# EFAbus/EFEX/STANAG3910 Word Count error detection

Roland Gamper, Lahniss Sarl, September 2015

## Wrong Behavior, up to 7.8 release

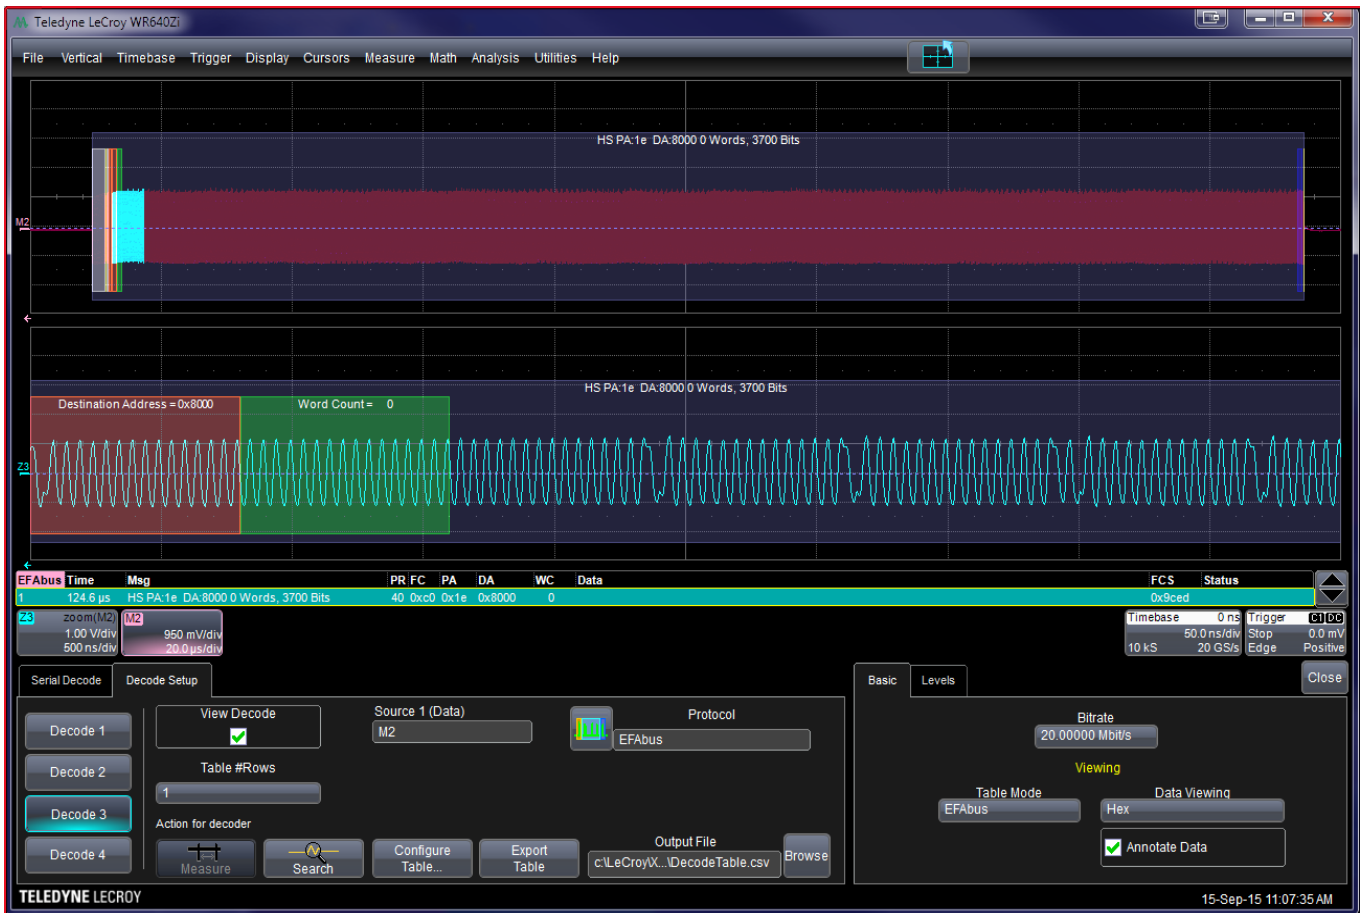
The header of the HS Frame is decoded, the CRC is decoded and found correct, but the **data words are NOT decoded**. The zoom shows the incorrect WC<sup>embedded</sup> of 0 causing the problem. Furthermore no error is flagged to alert the user.

By extension, a WC<sup>embedded</sup> of N ( $N < WC^{real}$ ) would have led to the decoding of only N words, but not the entire payload.

## Correct Behavior beginning with release 7.9

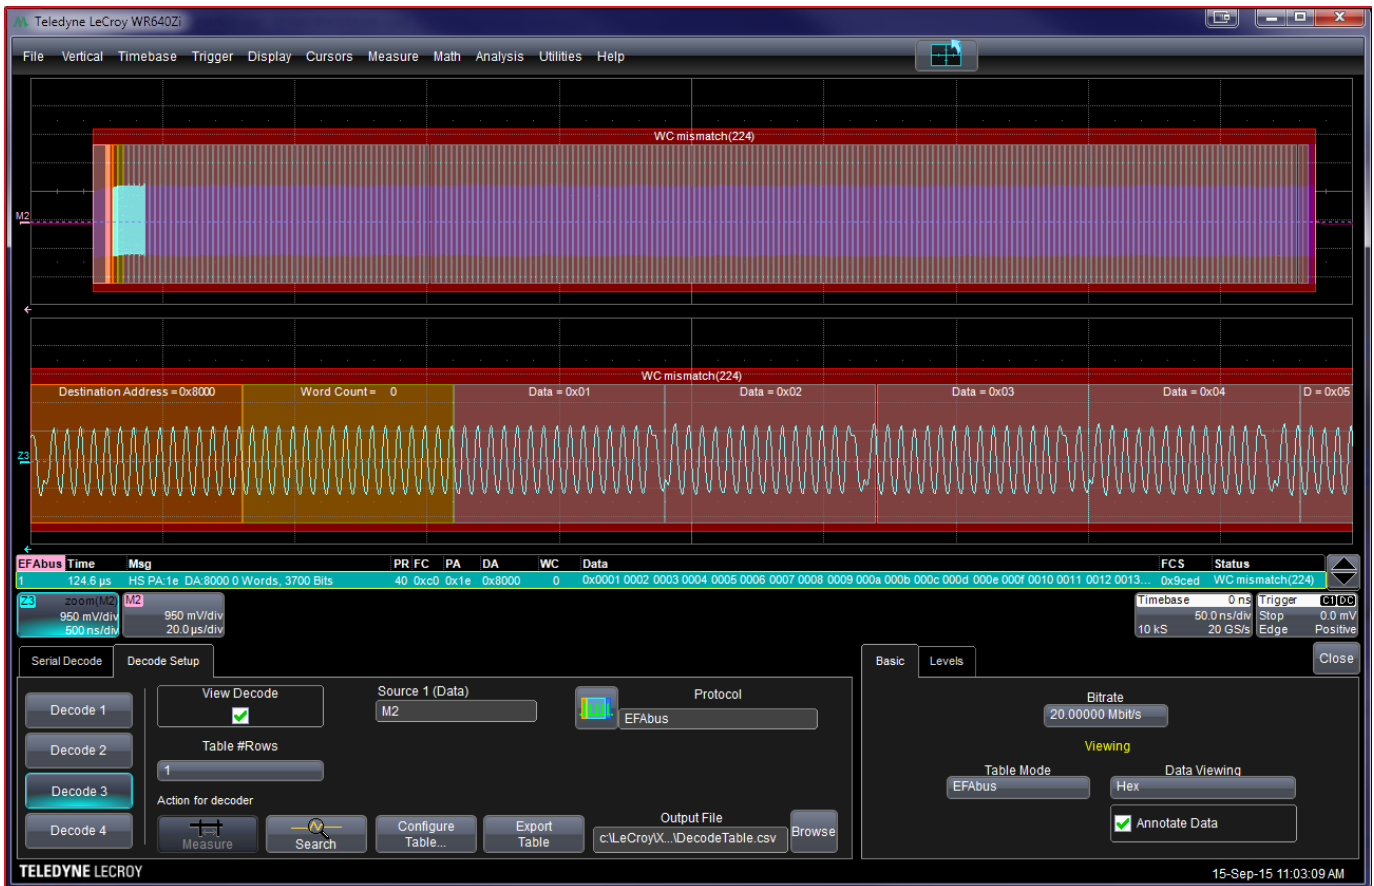
The complete Frame is now decoded, **including data words**. This is in line with the philosophy that all decoders will do their best to interpret the data, even faulty, **but** the decoder will flag errors and attempt to provide information to the engineers. This behavior helps understanding the root cause of the issue and fix it.

- All of the words of the HS Frames are always decoded, regardless of the embedded WC.
- When the embedded WC matches the number of words in the Frame, everything is deemed correct and no message at all appears in the Status column.
- When the embedded WC <sup>embedded</sup> does not match the number of words in the Frame (WC <sup>real</sup>), the WC mismatch is flagged in the Status column, and the **entire HS Frame is colored in red**, attracting the attention to the error.
- No difference is made between  $WC^{embedded} < WC^{real}$  and  $WC^{embedded} > WC^{real}$
- In both cases  $WC^{real}$  is displayed in parenthesis in the Status column (here 224), allowing immediate comparison with the  $WC^{embedded}$  (here 0) of the same message in the WC column.
